# ***Interactive comment on “Surface movement above an underground coal longwall mine after closure”***

nhess-2016-134 Author comments on Referees comments for paper “Surface movement above an underground coal longwall mine after closure”, A. Vervoort

Fig. 1. possible new figure

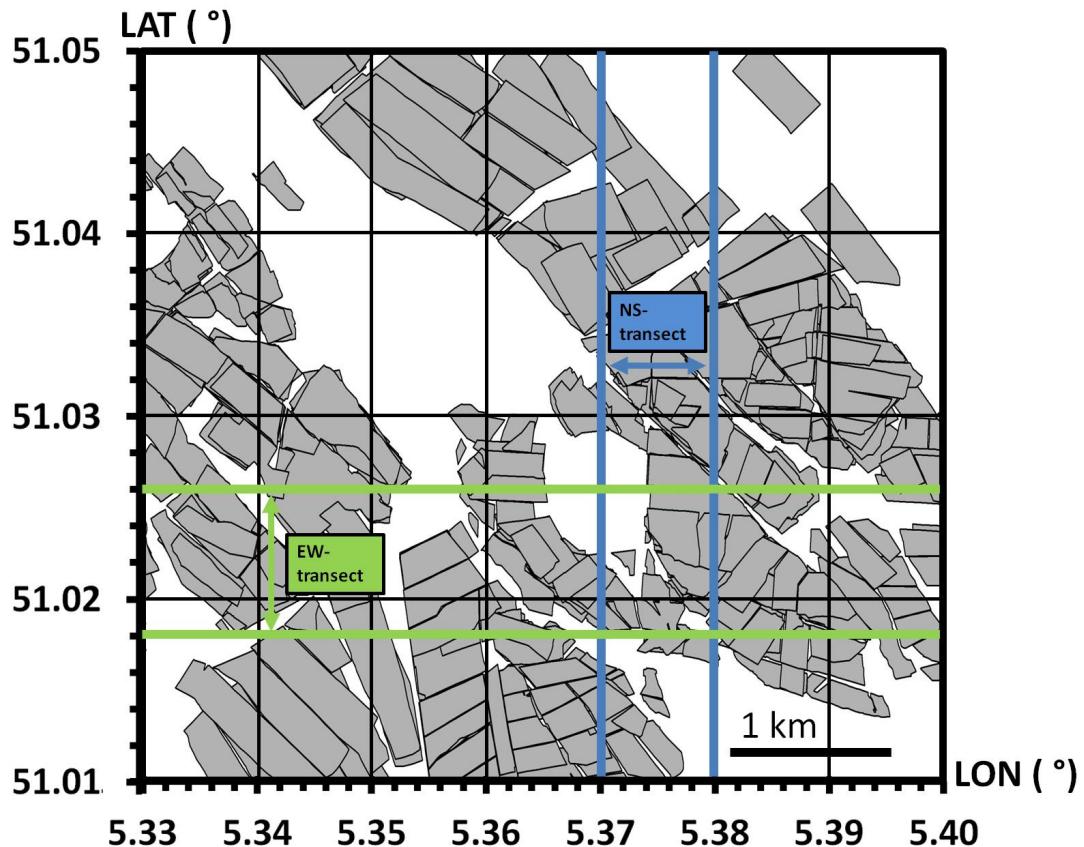
3) On the Figures 1, 3 and 6 there is no section line drawn. It is a pity, because it

would make easier the interpretation of the results presented on Figures 4, 7 and 8; This could be done, but I would then only do on Figure 1, plus I would repeat this Figure (i.e. a new Figure before the old Figure 4) and not overloading the original Fig.1 with various lines; similar to Fig. 12, which is Fig. 1 plus the position and labels of the various locations considered in the analysis of relationships. This new Figure would look like the following, which so far I have not yet integrated in the revised paper: [See attached] I am rather in favor of not including this new Figure, but I leave it up to the editor to decide on it.
